LUSCOMBE AIRPLANE CORPORATION
West Trenton, New Jersey

ENGINEERING BULLETIN #11

January 11, 1940

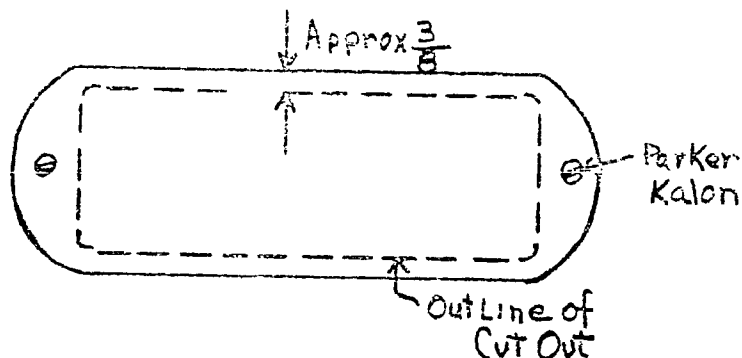
For cold weather operation, it may be found that the engine will not maintain a satisfactorily high oil temperature. This condition may be corrected by closing the center cooling port in the cowling. It is recommended that this be done as per sketch above, using approximately .032 aluminum or aluminum alloy for the cover plate.
